**MEMORANDUM**

SUBJECT: CLARIFICATIONS TO MHRB PERMIT 2018-0002 MCCSD WATER TREATMENT PLANT

The Review Board granted this permit to construct a 1,000-square-foot building with wooden windows and doors; install signs and striping for parking; remove aluminum window and air vents on the southeast corner of the press building; and others (See attachment B). In 2019, the architect submitted for Building Plan Check Review revised drawings that differ from MHRB Permit 2018-0002 as follows:

SHEET A-6  
 SEQ 1  
 DATE 04/2019  
 PROJ. NO. 416076

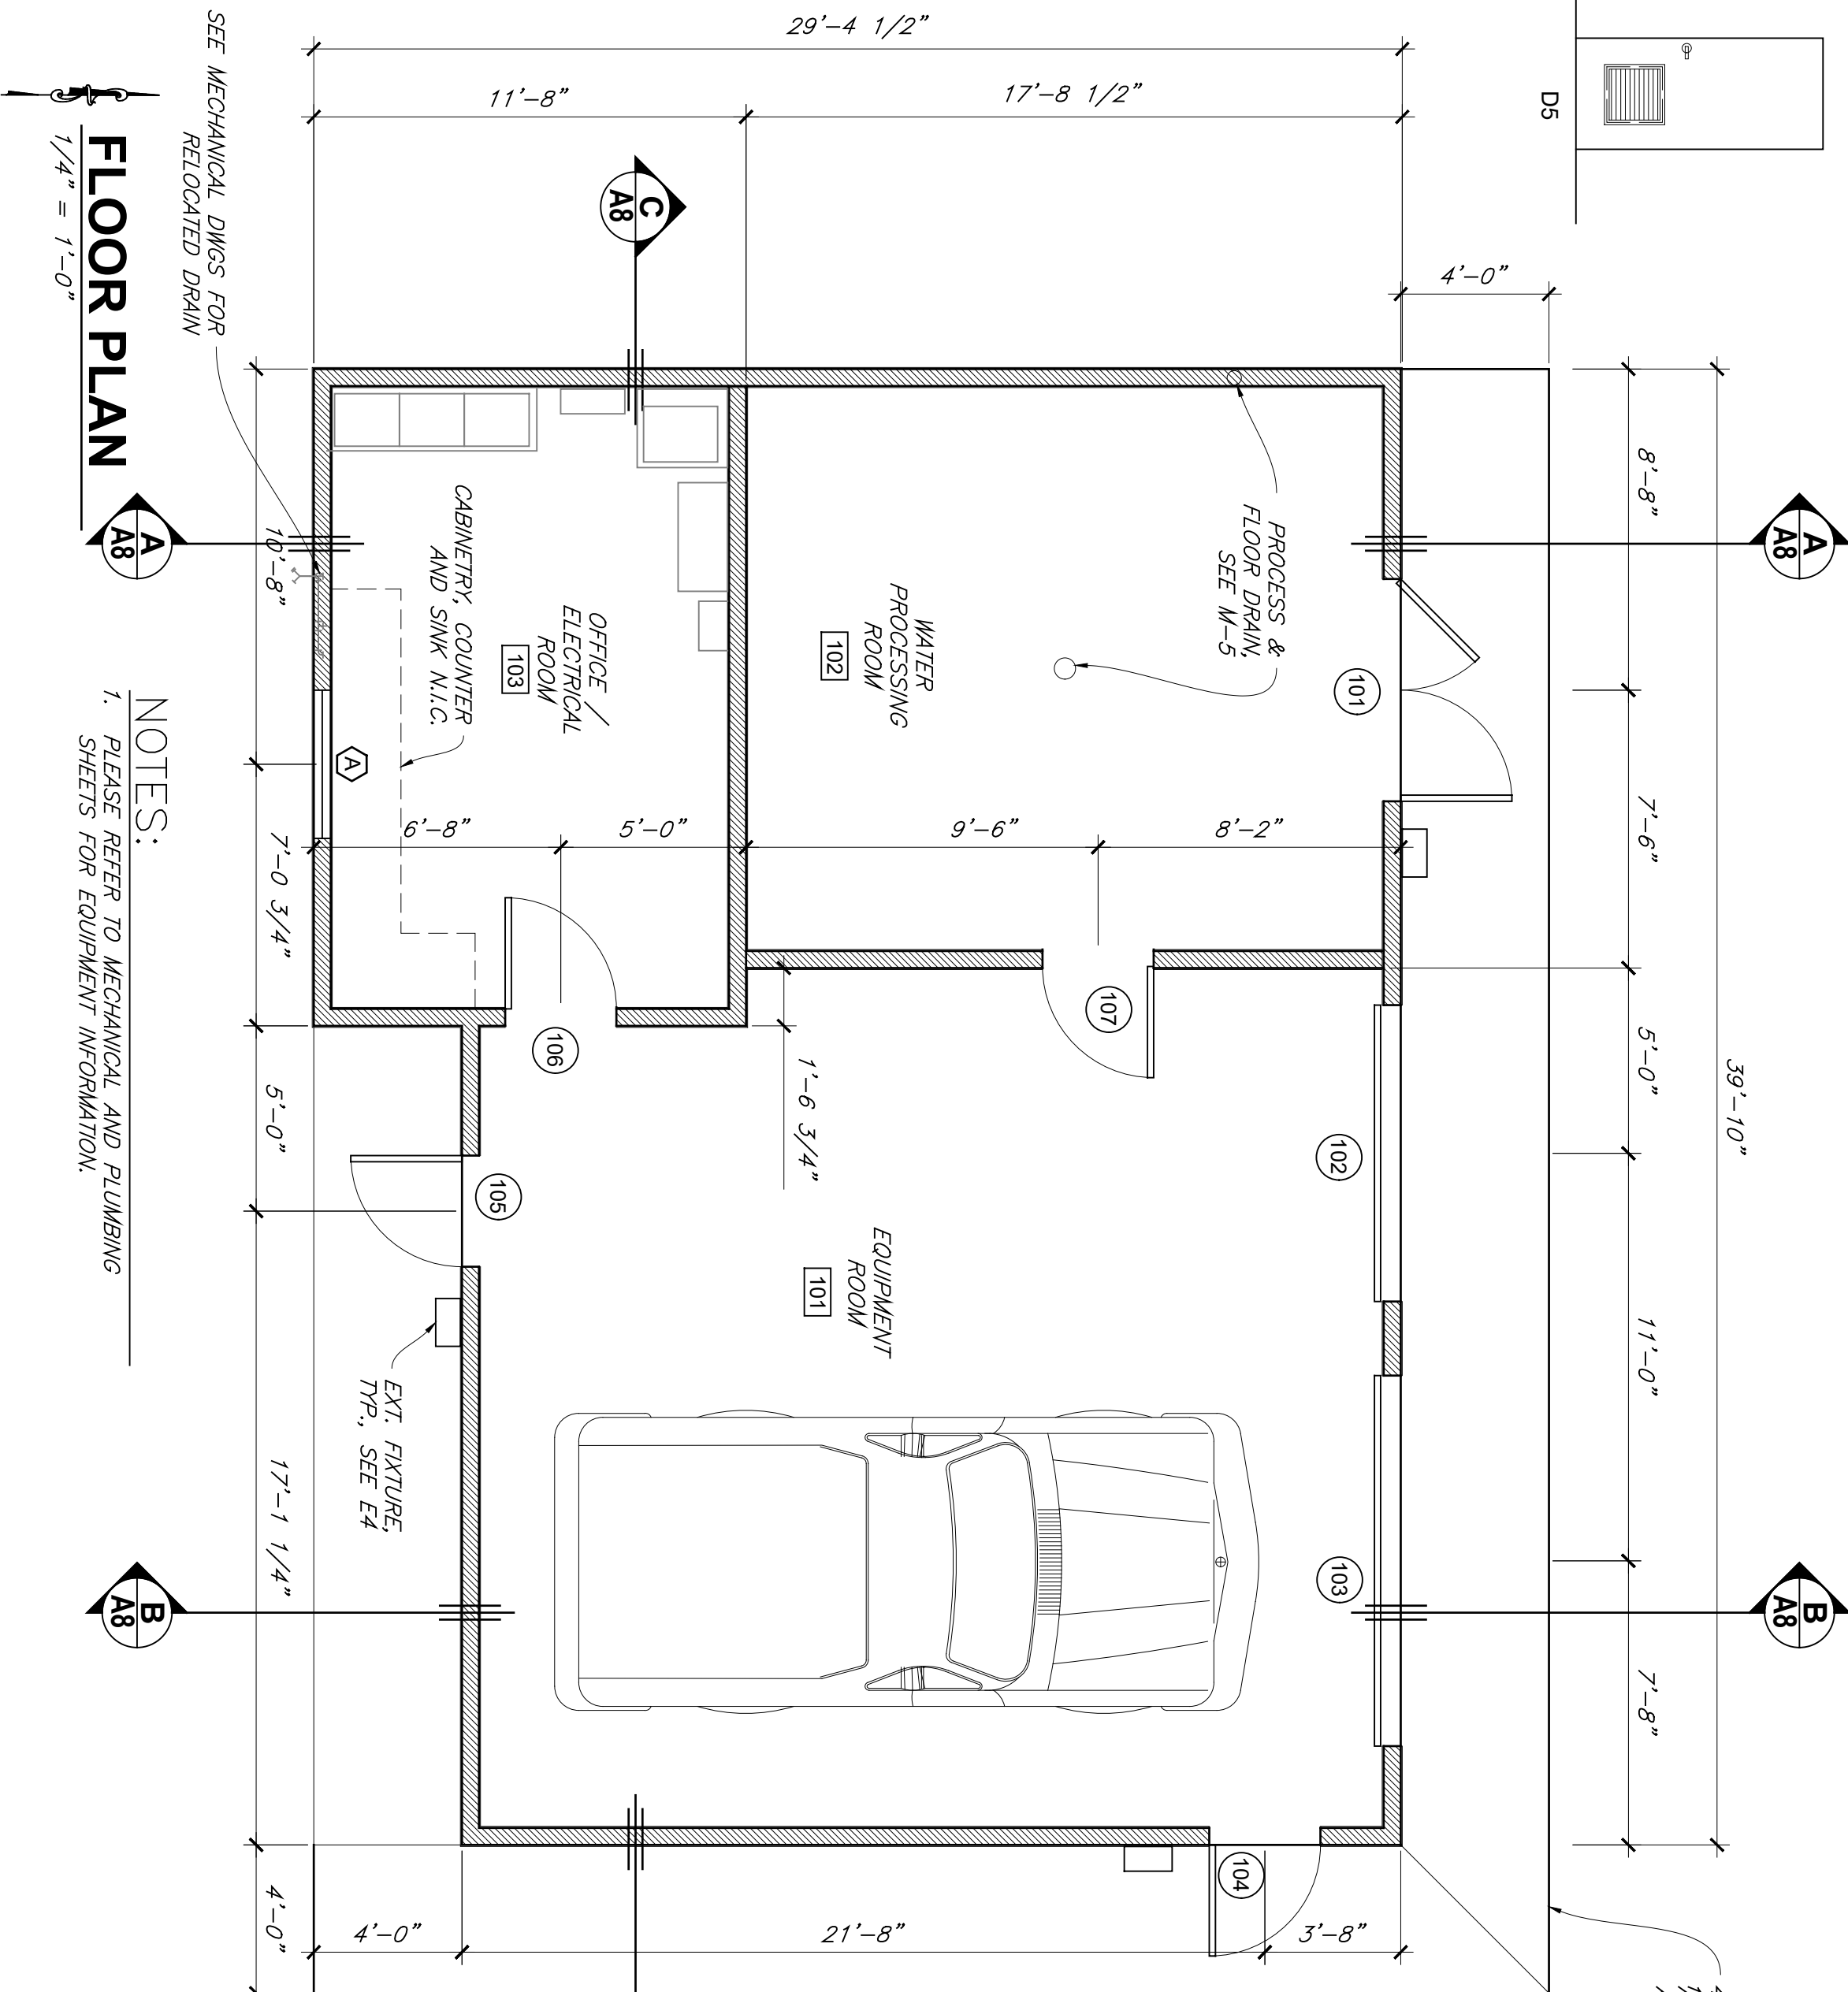
3. Drawings specify fiberglass window frames and doors on the Chlorine Building and the Press Building. Fiberglass differs from the wood window frames and doors specified in MHRB Permit 2018-0002 (See Attachments A and C Sheets A-4 and A-6). Staff recommends that the revised drawings specify exterior wooden doors and wooden window frames, including the proposed replacement door on the Press Building.

4. Changes to the Chlorine Building's north elevation are, from left to right, the left most door and middle door details differ from the MHRB Permit (See Attachments A and C Sheets A-6 and A-7). To the right, revised drawings show two doors with levered air vents replacing the MHRB permitted rollup door and its adjacent human door. Visibility of the Chlorine Building's north elevation would be limited to areas within the facility; therefore, Staff recommends the Review Board find these amendments consistent with their action granting MHRB Permit 2018-0002.

**RECOMMENDATION:** Acknowledge MHRB Permit Condition #7 anticipates potential changes to this public works project. Direct Staff to amend MHRB Permit 2018-0002 and to approve drawings specifying wood doors and wood window frames. Alternatively, direct the applicant to apply for a new permit.
